Addendum Number 1 to
Request for Bids
Sale of Wastewater System
Issued by the Township of Long Hill, New Jersey
on April 18, 2019

Addendum Number 1 Issued
May 13, 2019

APPENDIX 1 to
ADDENDUM NO. 1
VENDOR QUESTIONS/DATA REQUESTS AND
TOWNSHIP RESPONSES

LONG HILL INCLUSIONARY SITE MAPS

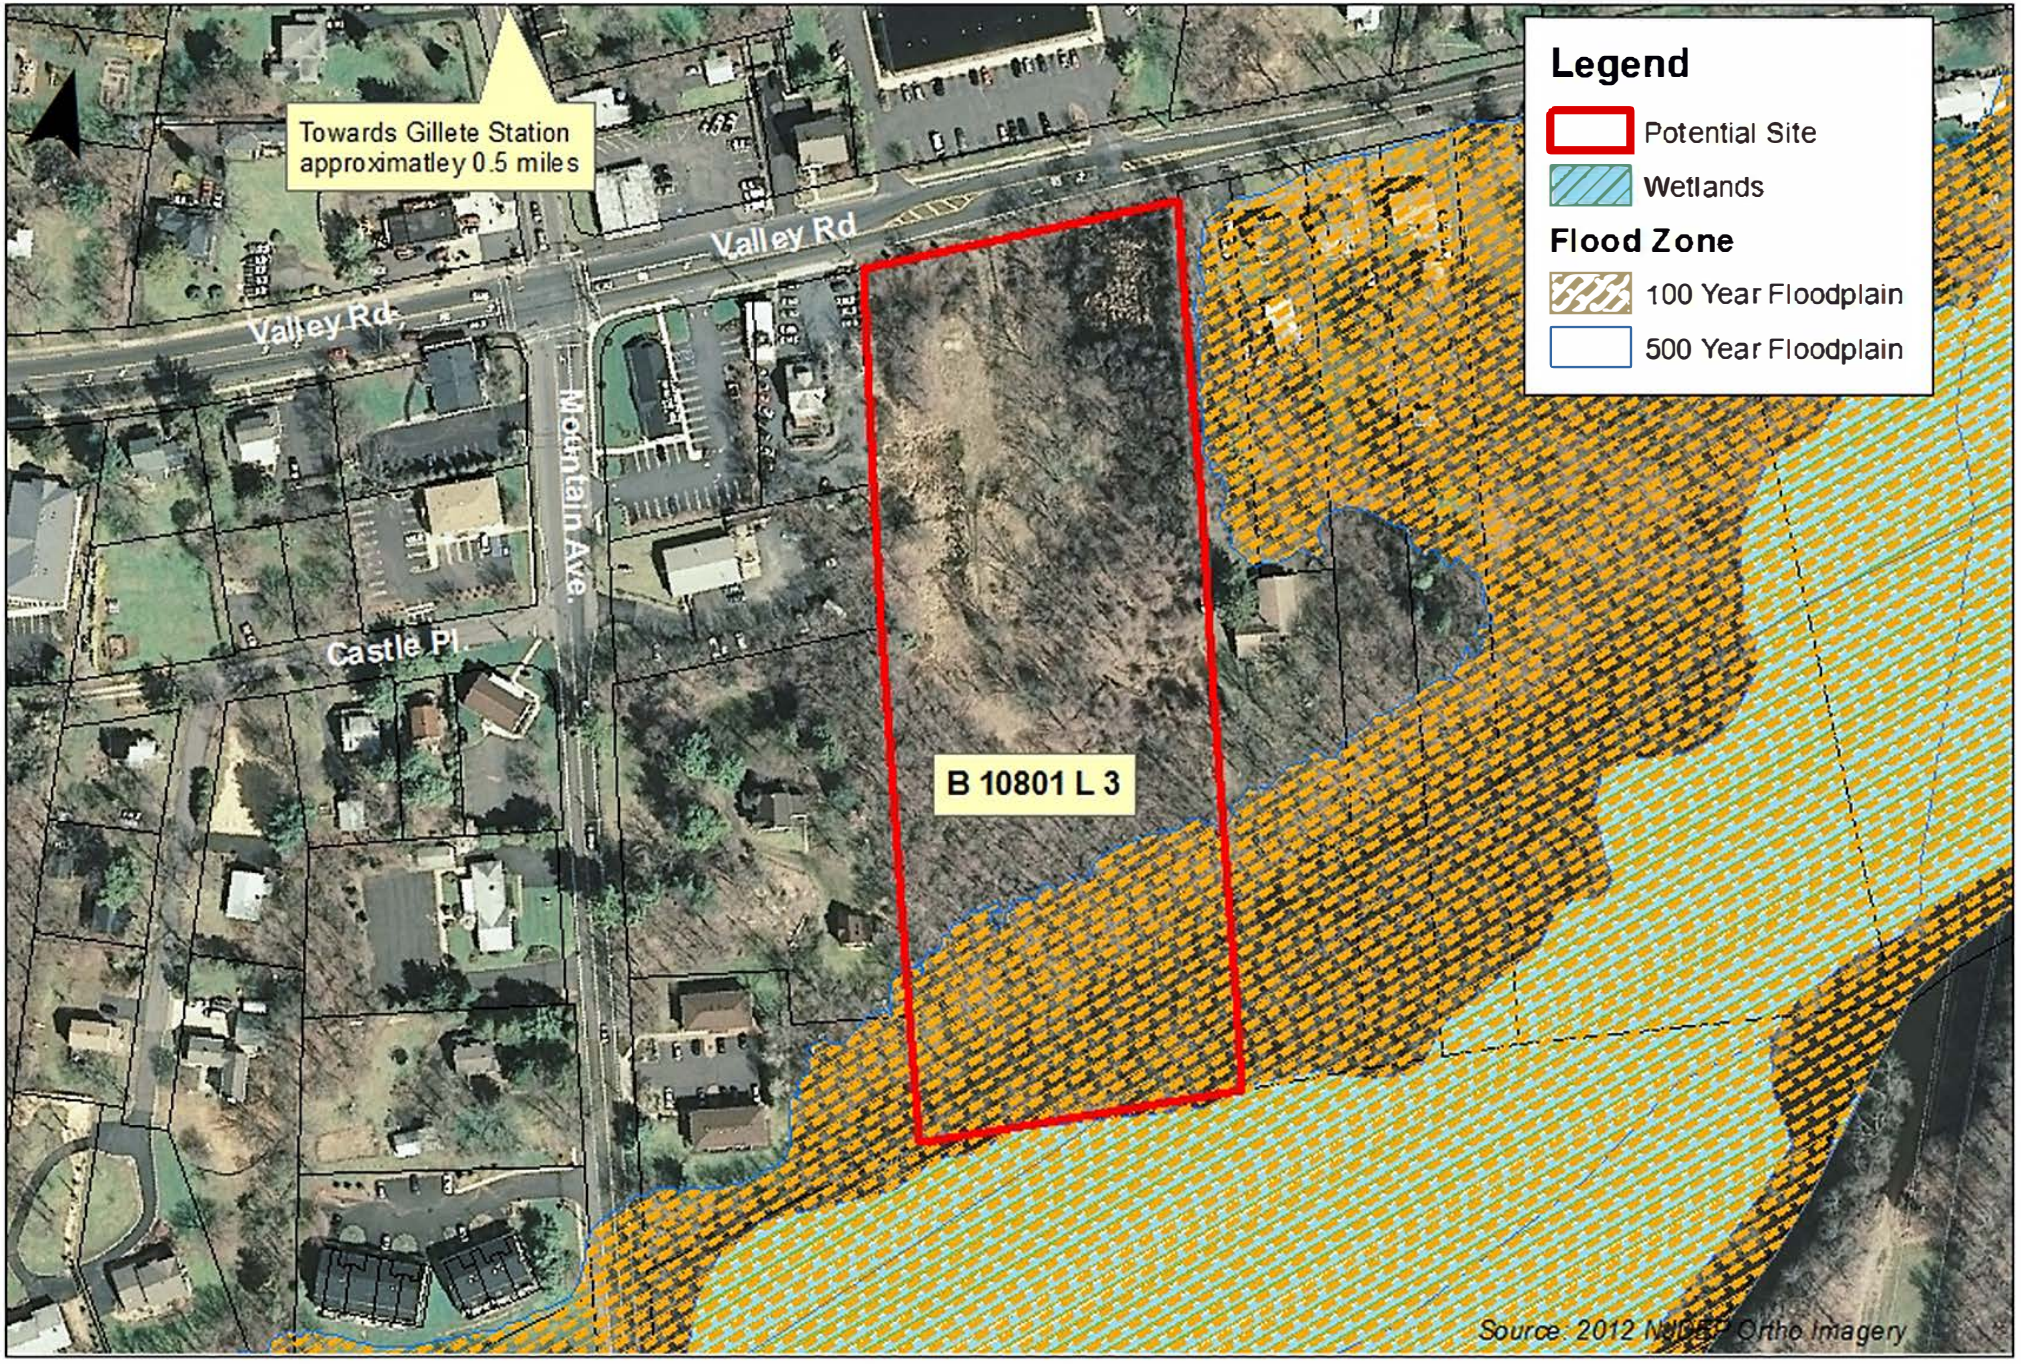
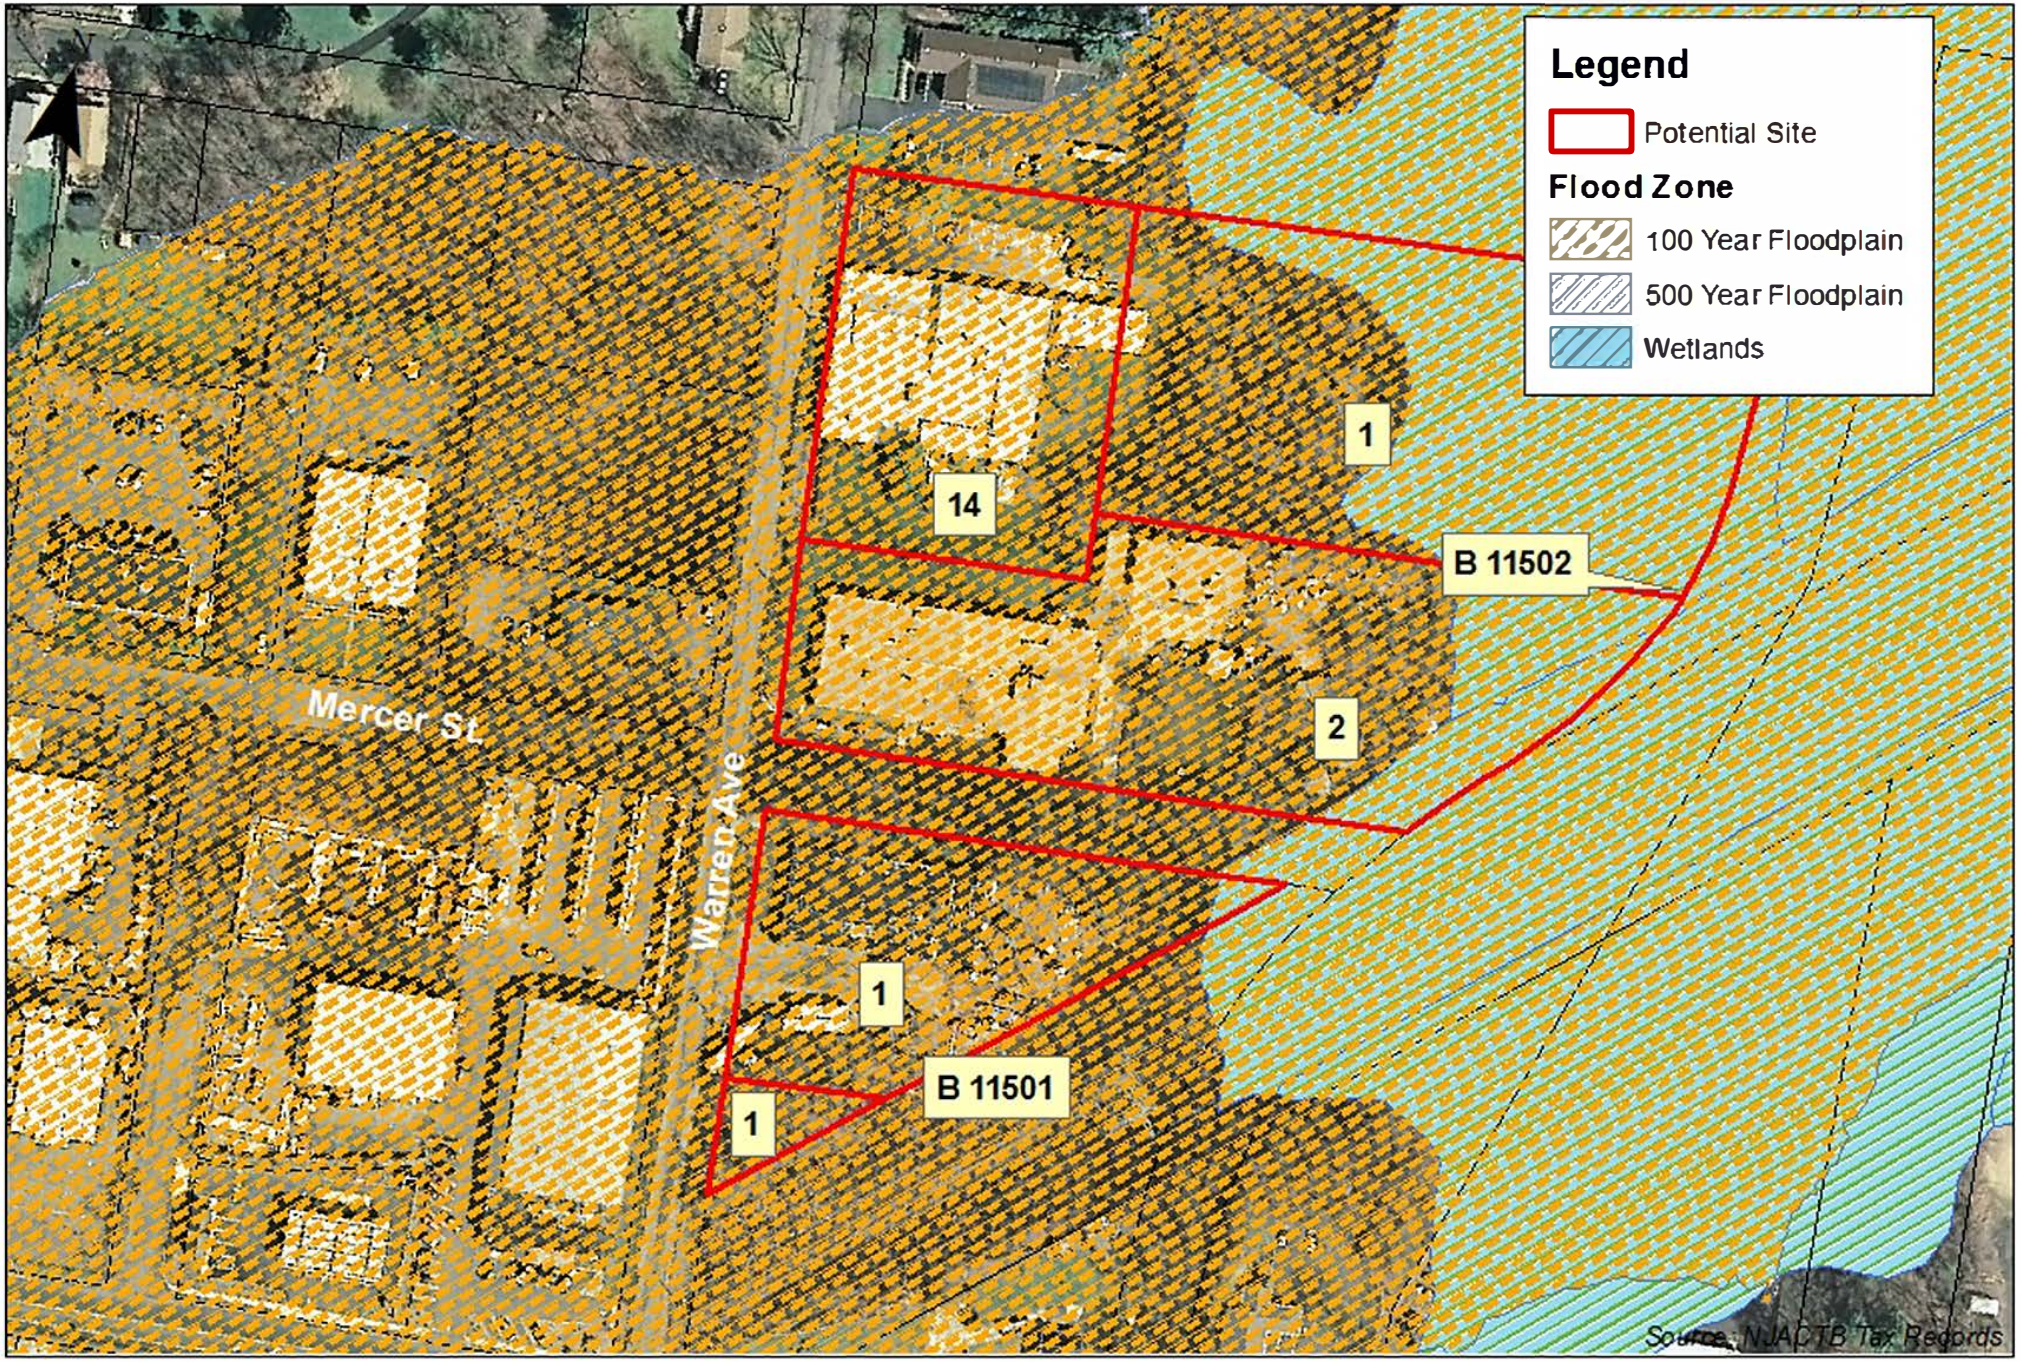
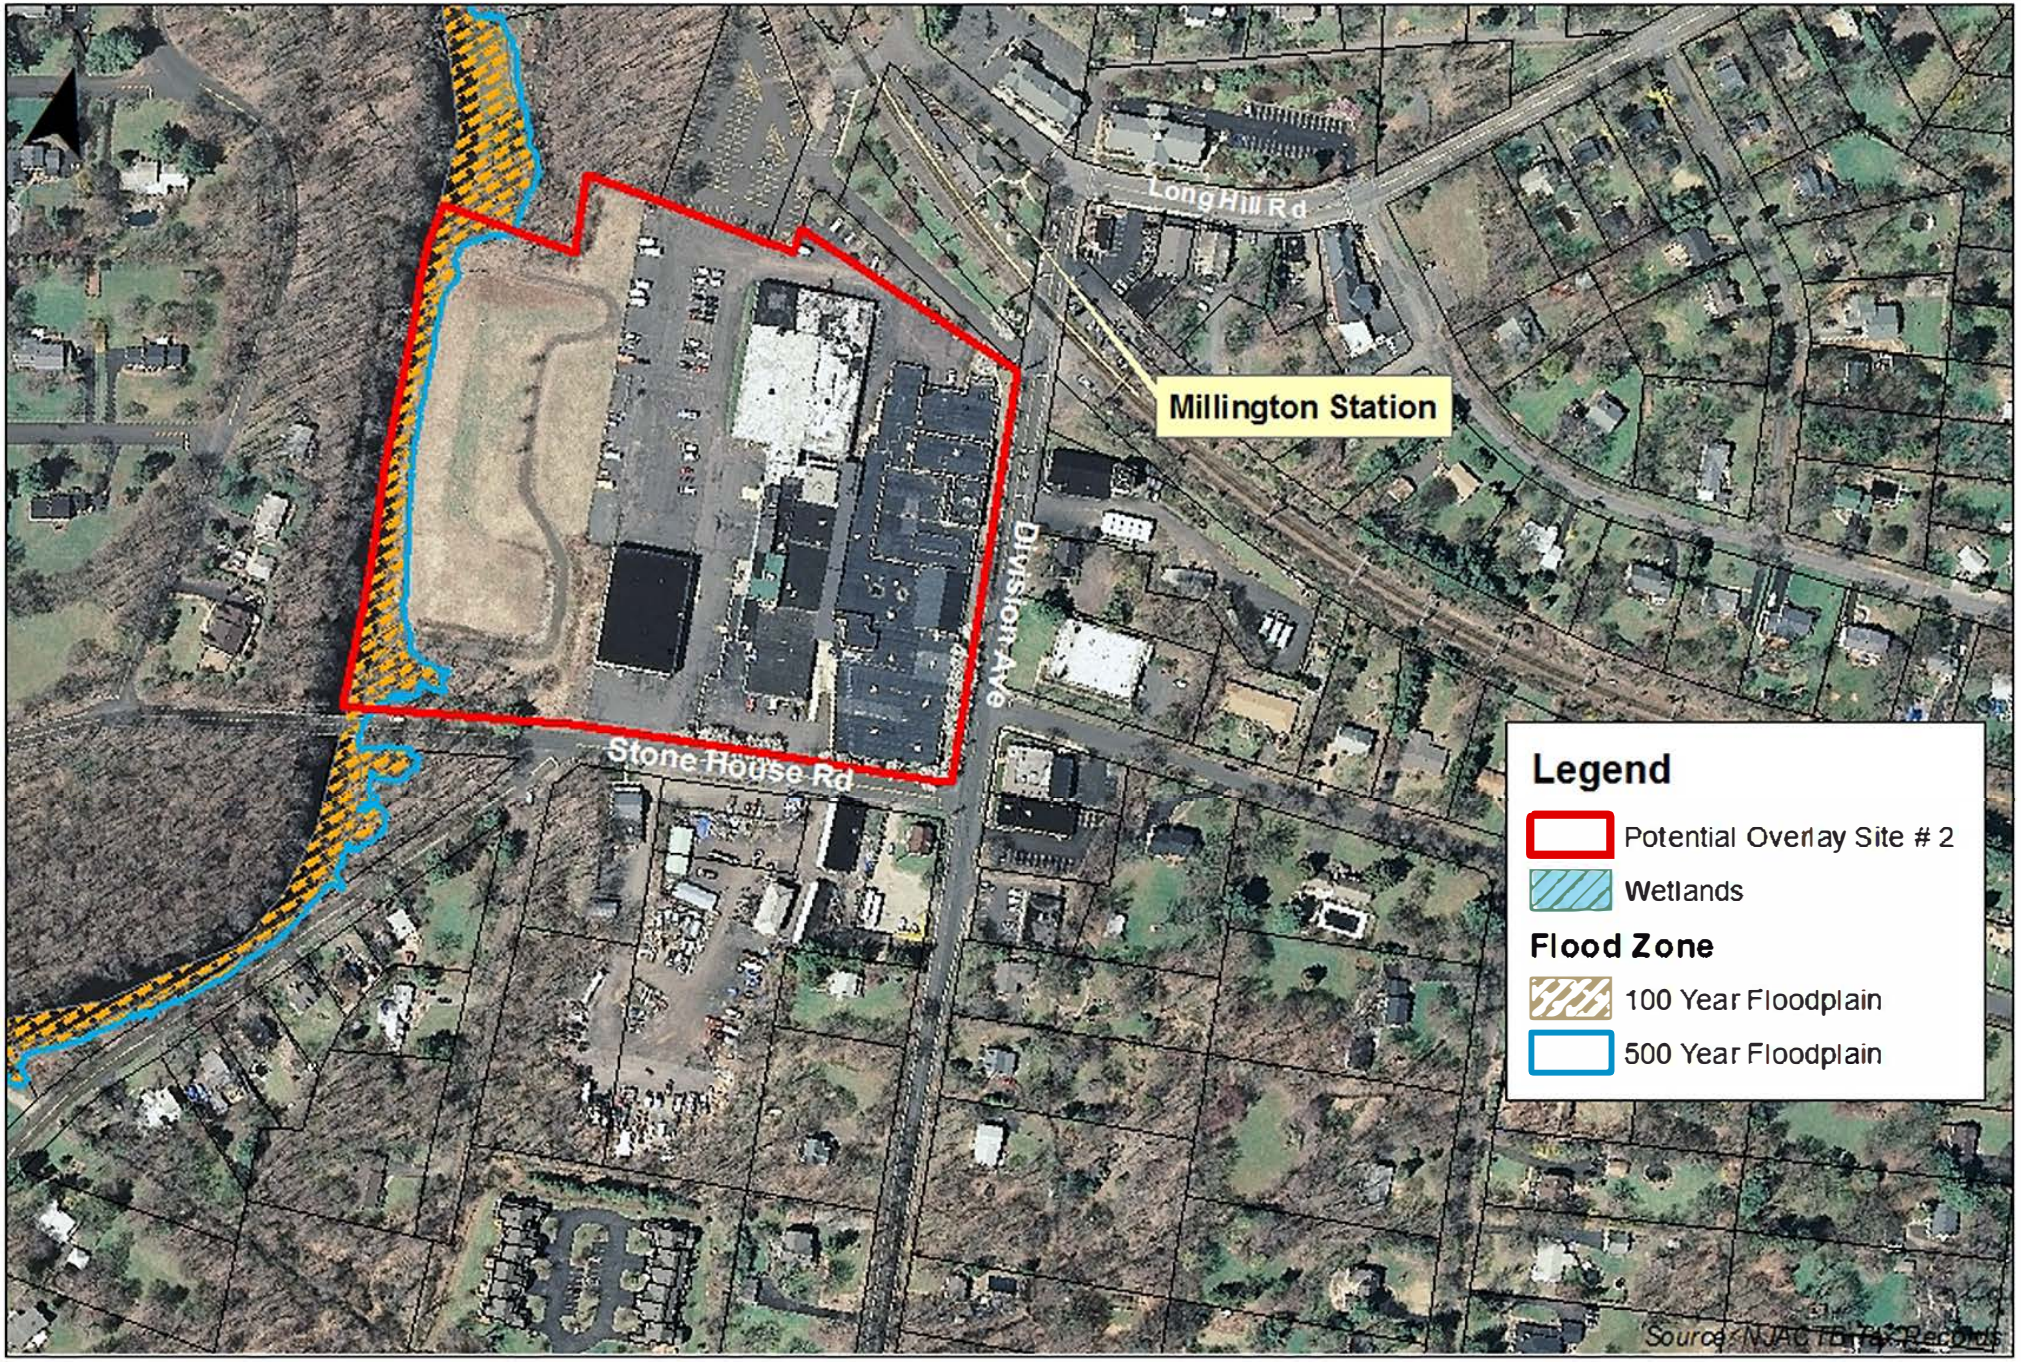
Question 26: Please provide aerial or plan drawing(s) showing proposed location(s) of affordable housing locations and other redevelopment areas associated with the 100,000 GPD and 30,000 GPD reserved flow request by the Township.

Response: Included as Attachment 1A (Long Hill Inclusionary Site Maps) and Attachment 1B (Valley Road Redevelopment Area Map) are aerials for both affordable housing sites and the Valley Road redevelopment.
